# Product Change Notification

## Cable assembly iFLEX E2

**PCN-no.** WMC-PCN-2023-0402-12546  
**Announcement date** April 24, 2023  
**Subject** The cable –W02– of the cable assembly is replaced by another type

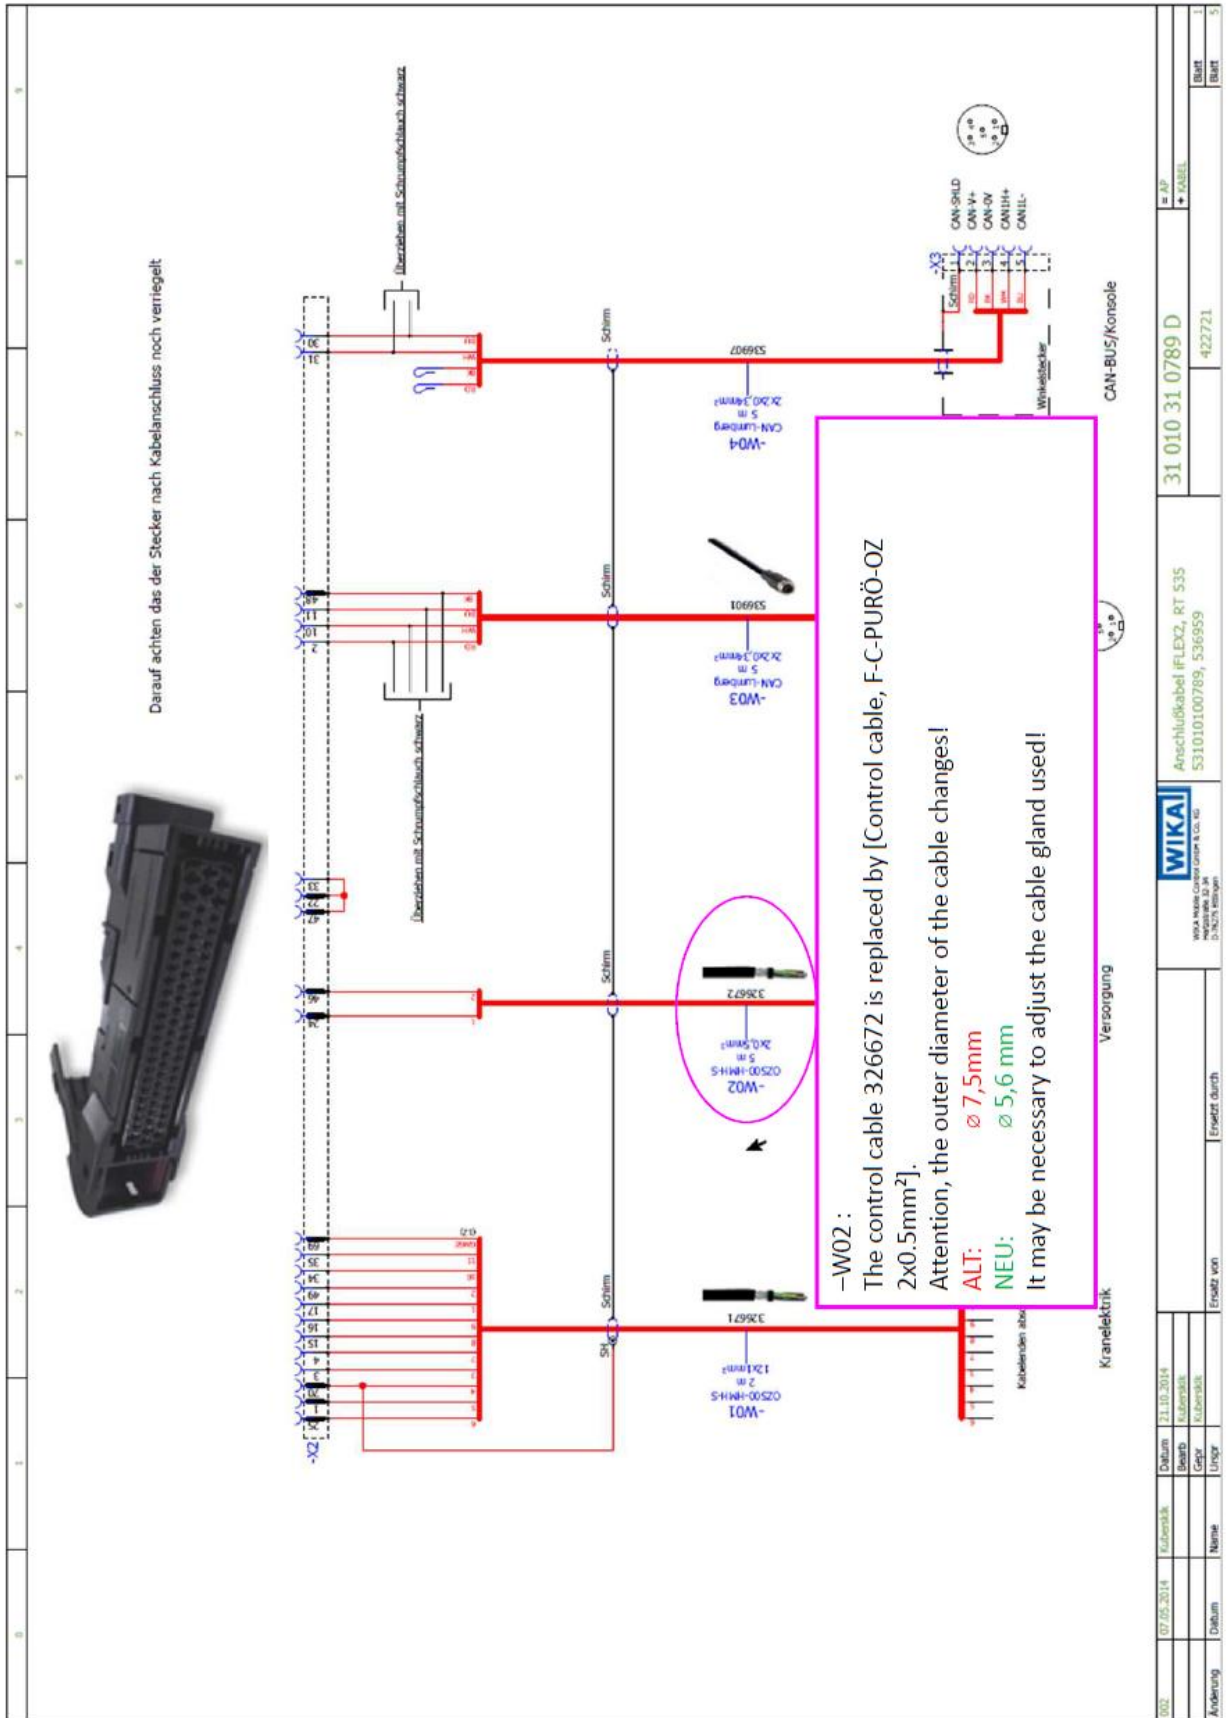
**Description** The cable –W02– is replaced by [F-C-PURÖ-OZ 2x0.5mm²].

Attention, the outer diameter of the cable has changed!

Old: Ø 7.5 mm

New: Ø 5.6 mm

Within the scope of the application, it may be necessary to adapt the cable gland used to the changed cable diameter!

**Measures** Identification of cable –W02– is possible in the wiring diagram
